Virgil C. Summer Nuclear Station (VCSNS) Units 2 and 3
Combined License Nos. NPF-93 and NPF-94
Docket Nos. 52-027 & 52-028

Subject: VCSNS Units 2 & 3 LAR 14-14: Request for License Amendment:
Structural Design of Auxiliary Building Floors

Request for License Amendment:
Structural Design of Auxiliary Building Floors
(LAR 14-14)

DESIGN SUMMARY OF FLOOR AT ELEVATION 135'-3"
 AREA ~~4-2~~ (MAIN CONTROL ROOM CEILING)

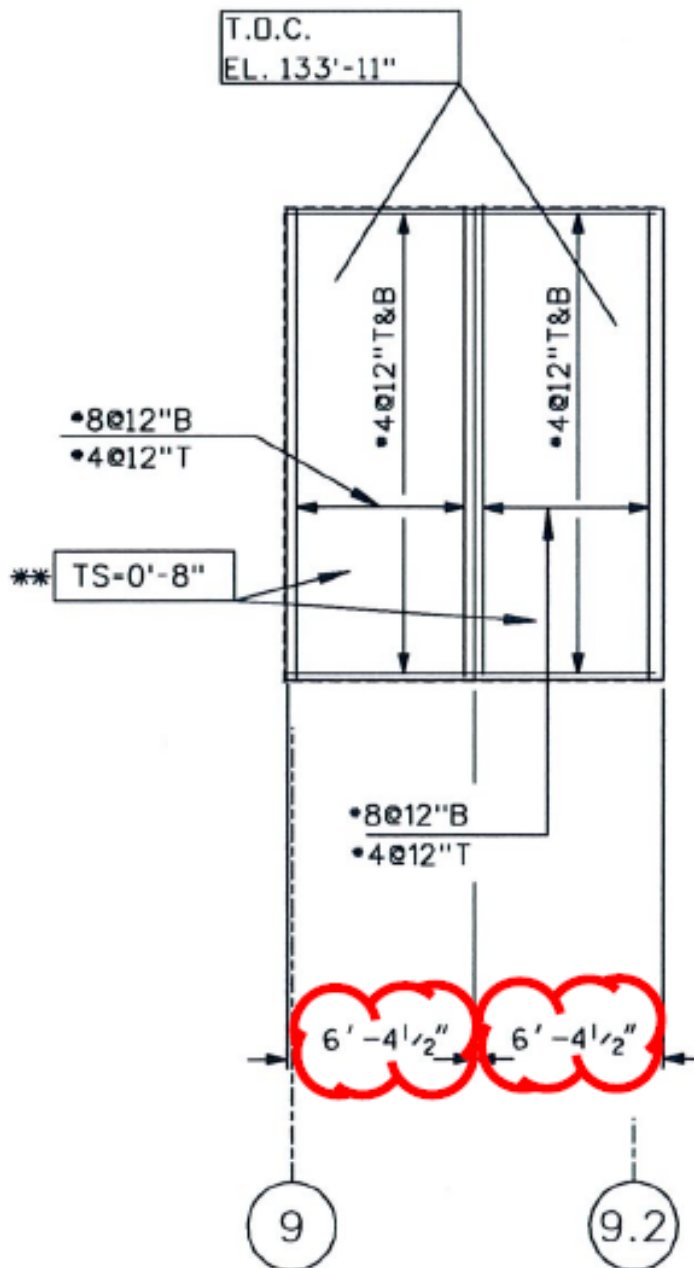
UFSAR Table 3H.5-13, Design Summary Of Floor At Elevation 135'-3" Area 1 (Main Control Room Ceiling) – Revise the title of this table to read as shown below.

UFSAR Table 3H.5-13, Design Summary Of Floor At Elevation 135'-3" Area 1 (Main Control Room Ceiling) – Revise the information in the table as shown below.

- H. Change to UFSAR Table 3H.5-13 (Change Activity 7)
 - 1. Revise the table title to change the area identified in the title.
 - 2. Reformat the table and add text to improve comprehension.

- 3. Define construction loads.
 - 4. Revise the calculational results for maximum bending moment and maximum shear force and round values to two significant digits.

- 5. Define tension steel.
 - 6. Add an exception for reinforcement near penetrations and other interferences.
 - 7. Revise to add values to the table for the reinforcement to resist negative bending.

- 8. Add an exception for shear studs near penetrations and other interferences.
 - 9. Add a clarification that the design shear strength is not reduced for in-plane axial forces.

- 10. Remove from the table the information on shear stud calculated required spacing.
- I. Change to UFSAR Figure 3H.5-8 (Change Activity 9):
 - 1. In the view labeled Floor EL. 133'-11" (Precast Concrete), change the panel width from 5'-11" to 6'-4½".

FLOOR EL. 133'-11"
(PRECAST CONCRETE)
NOTES 1, 3, 6, 7, 16, 17

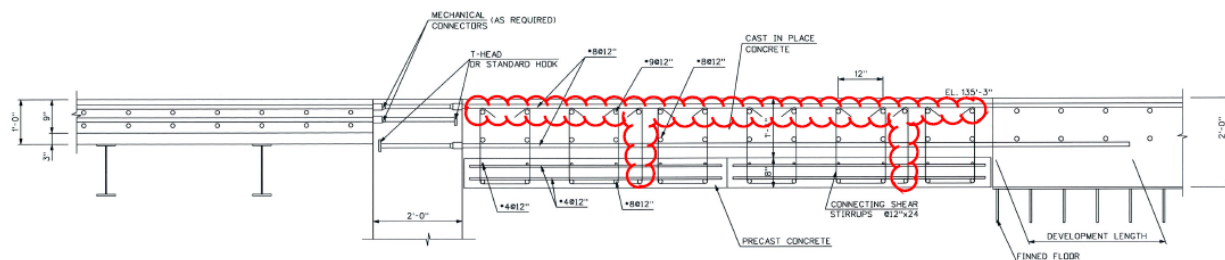
**UFSAR Figure 3H.5-8, Auxiliary Building Operations Work Area (Tagging Room) Ceiling –
Revise the information for Floor El. 133'-11" (Precast Concrete) as shown below.**

**UFSAR Figure 3H.5-8, Auxiliary Building Operations Work Area (Tagging Room) Ceiling –
 Revise the information for Section C (Looking West) as shown below.**

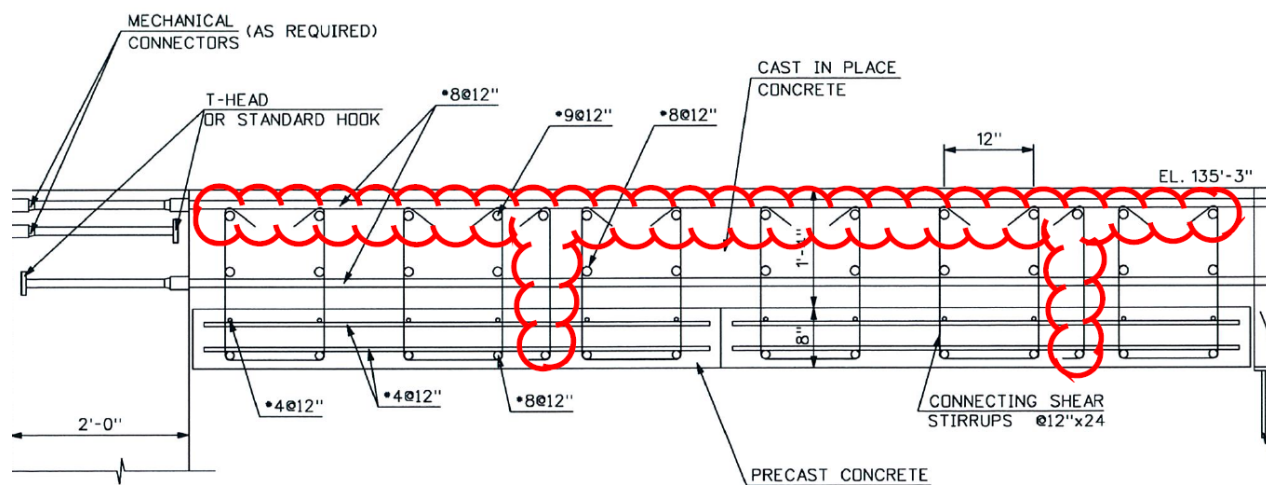
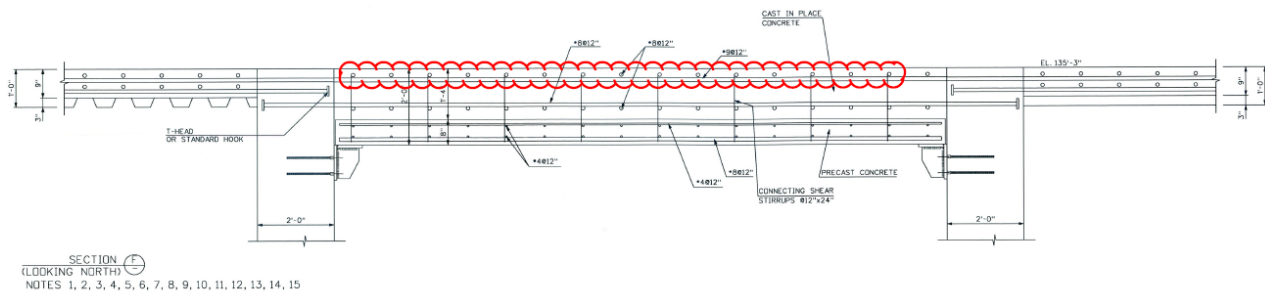
Additional detail of changed area.

- 2. In Section C, add a row of single stirrups to each of the two precast panels.
 - 3. In Section C and F, reorient the hooks on the stirrups to be in the plane of the double stirrup.

**UFSAR Figure 3H.5-8, Auxiliary Building Operations Work Area (Tagging Room) Ceiling –
Revise the information for Section F (Looking North) as shown below.**

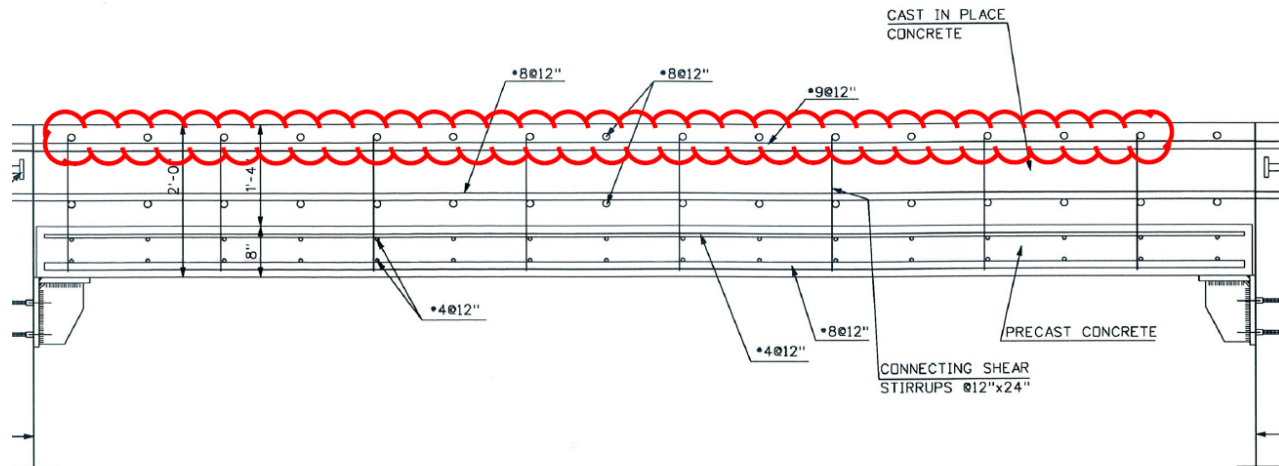
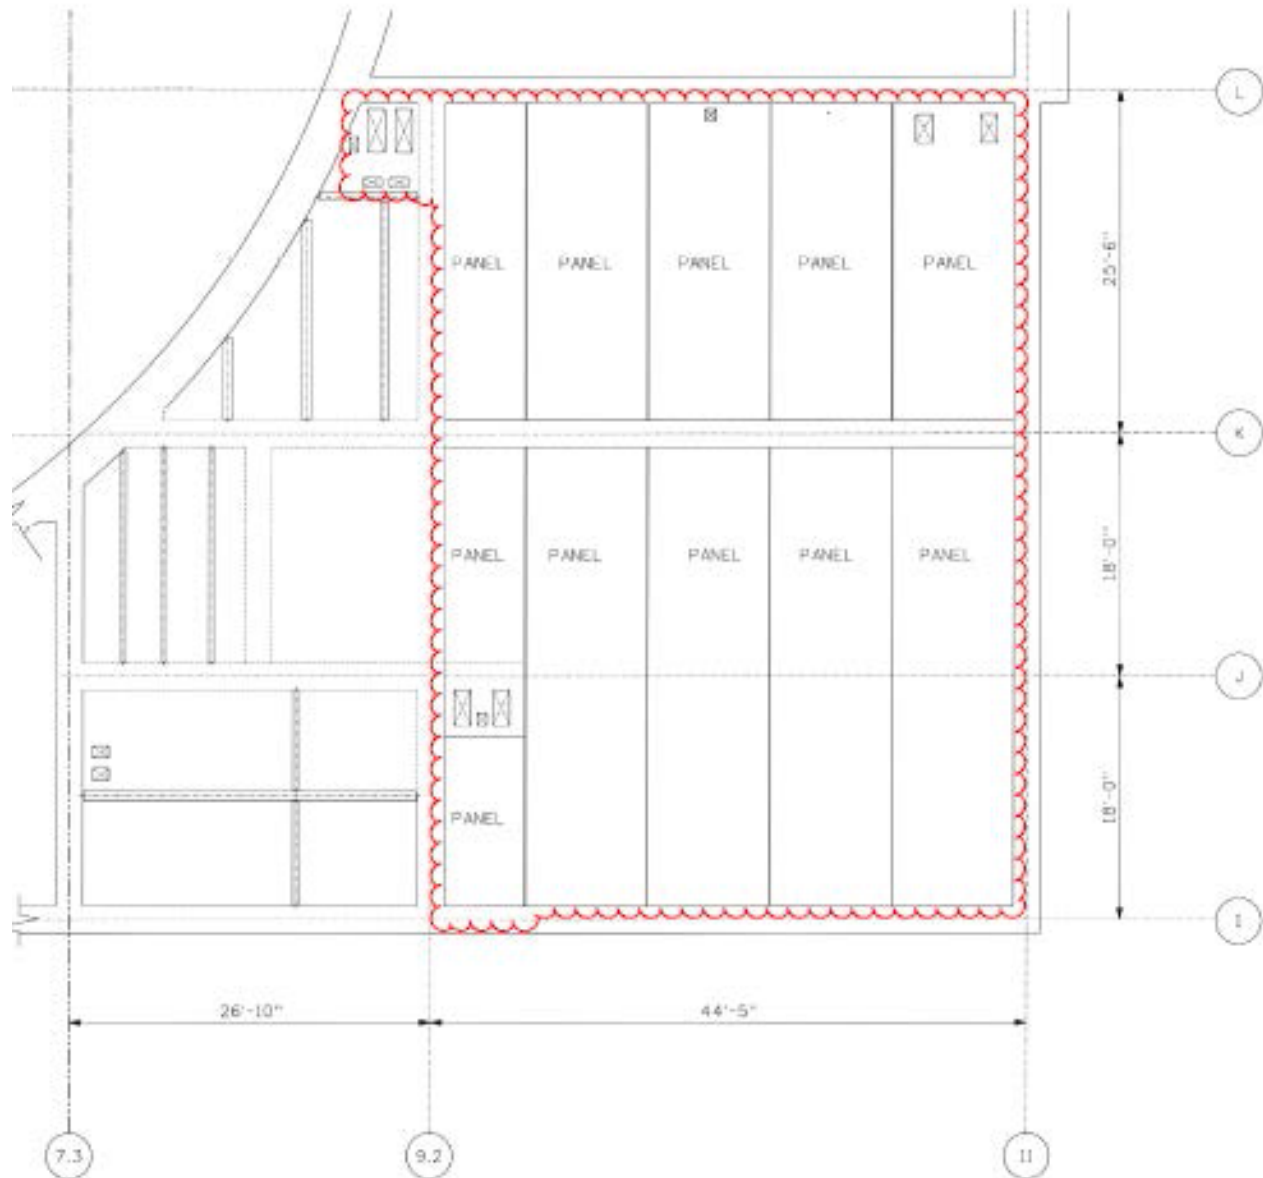
Additional detail of changed area.

UFSAR Figure 3H.5-9 (Sheet 1 of 3), Auxiliary Building Finned Floor – Revise the information as shown below.

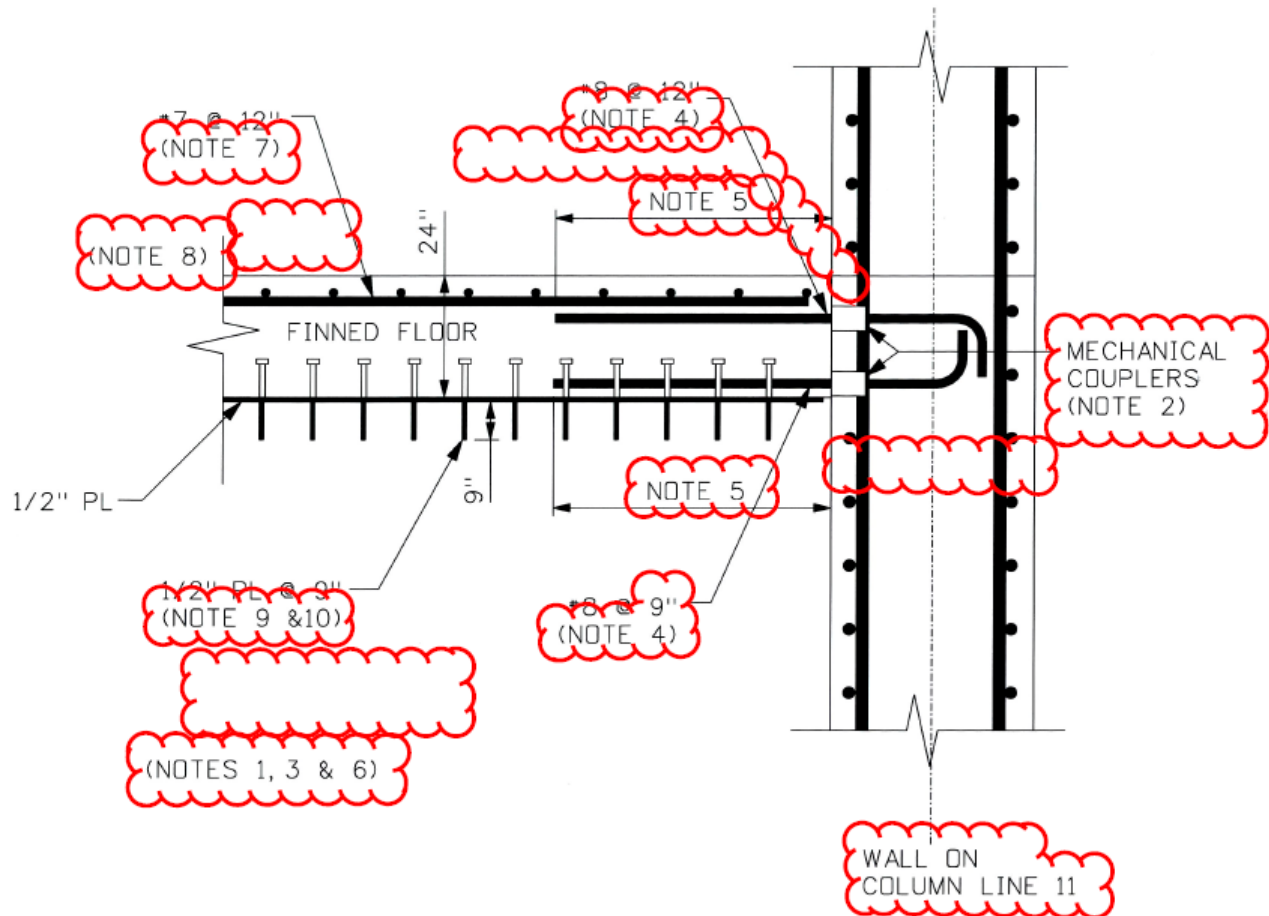
UFSAR Figure 3H.5-9 (Sheet 1 of 3), Auxiliary Building Finned Floor – Revise the information to add the Notes shown below.

1. DETAIL SHOWN IS SPECIFIC TO THE REINFORCED CONCRETE FLOOR AT EL. 135'-3" (MAIN CONTROL ROOM CEILING). REFER TO SUBSECTION 3H.5.4 AND OTHER NOTES FOR ADDITIONAL INFORMATION ABOUT DESIGN DETAILS FOR OTHER FLOOR SECTIONS AND FOR CONNECTIONS TO WALLS OTHER THAN THE WALL ALONG COLUMN LINE 11.
2. THE NUMBER OF STEEL PANELS USED TO CONSTRUCT THE FLOOR IS DETERMINED BY THE SIZE OF THE ROOM AND FABRICATOR CAPABILITIES.

- J. Change to UFSAR Figure 3H.5-9, Sheet 1 (Change Activities 1, 3, and 4):
 - 1. Revise the figure to show five finned floor steel plates between column lines 9.2 and 11 from column lines I to L.

- 2. Revise the figure to move the rectangular openings for HVAC ducts from along column line 11 near column lines I and J to along column line L near column line 11.

- 3. Add notes to the figure to provide the following information:
 - a. State that the section shown is a specific location and other locations will have variations in design details.

UFSAR Figure 3H.5-9 (Sheet 2 of 3), Auxiliary Building Finned Floor – Revise the information to add the Notes shown below.

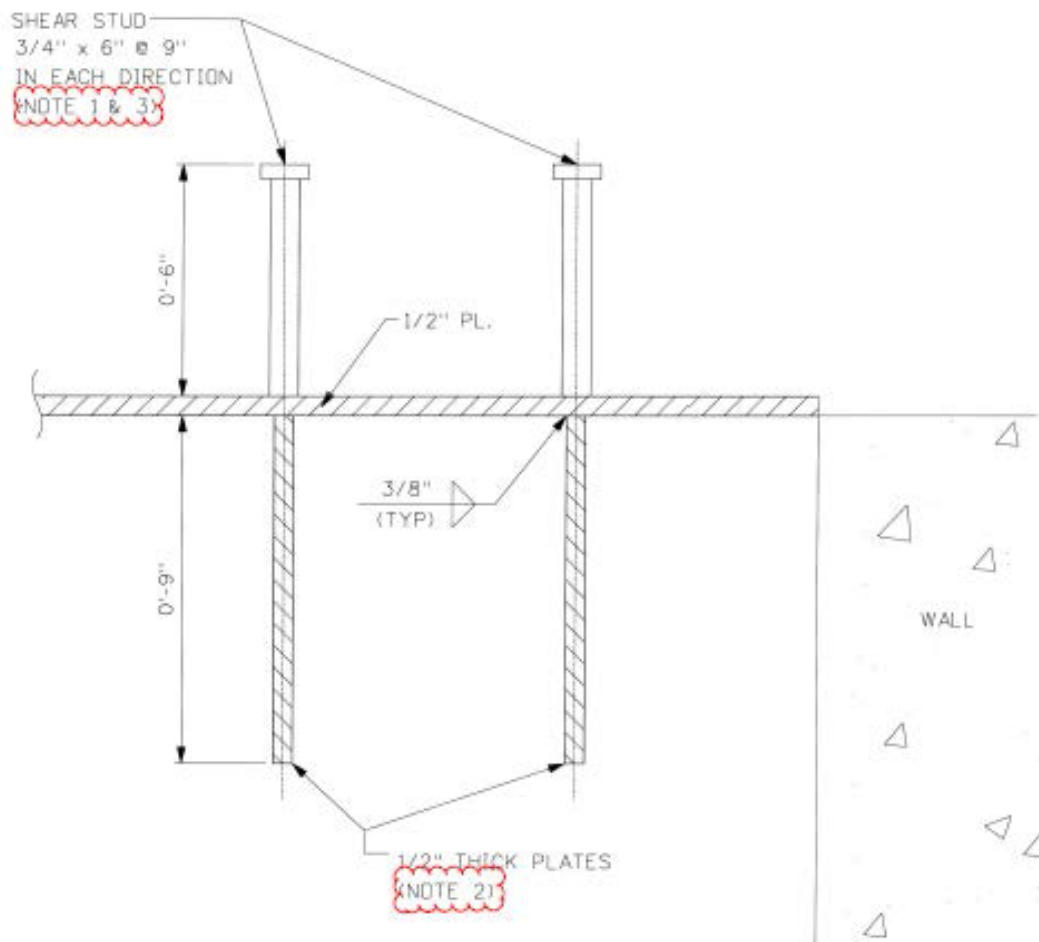
UFSAR Figure 3H.5-9 (Sheet 2 of 3), Auxiliary Building Finned Floor – Revise the information to add the Notes shown below.

1. DETAIL SHOWN IS SPECIFIC TO THE REINFORCED CONCRETE FLOOR AT EL 135'-3" (MAIN CONTROL ROOM CEILING). REFER TO SUBSECTION 3H.5.4 AND OTHER NOTES FOR ADDITIONAL INFORMATION ABOUT DESIGN DETAILS FOR OTHER FLOOR SECTIONS AND FOR CONNECTIONS TO WALLS OTHER THAN THE WALL ALONG COLUMN LINE 11.

8. THE ELEVATION OF THE TOP OF CONCRETE IS BASED ON LOCATION AND DESIGN REQUIREMENTS FOR THE FLOORS.
9. THE DESIGN OF THE FINS VARIES AT LOCATIONS NEAR OPENINGS, PENETRATIONS, AND OTHER OBSTRUCTIONS AND DUE TO ATTACHMENTS TO THE FINS AND FLOOR PLATES.

10. THE CENTER LINE LOCATION OF THE SHEAR STUDS MAY VARY FROM THAT OF THE FINS.

- K. Revise UFSAR Figure 3H.5-9, Sheet 2, as follows: (Change Activities 1, 2, 5, and 8):
1. Revise spacing of the bottom reinforcement bar dowel to @9"

2. Remove reference to construction joint
 3. Remove designation of 135'-3" elevation; replace with Note 8
 4. Remove size of dowel length; replace with Note 5

5. Remove information on gap between steel plate and wall
 6. Replace the term "Mechanical Splices" with "Mechanical Couplers"
 7. Remove North – South designator

8. Revise wall designation to say "WALL ON COLUMN LINE 11"
 9. Add notes to the figure to provide the following information:
 - a. State that the section shown is a specific location and other locations will have variations in design details.

- b. State that headed reinforcement may be used.
 - c. Identify the requirements for development of headed reinforcement.
 - d. Identify the code requirements for reinforcement size and spacing and provide the range of reinforcement size and spacing.

- j. State that the center line of the location of the studs may vary from that of the fins.
- L. Revise UFSAR Figure 3H.5-9, Sheet 3, as follows: (Change Activity 1):
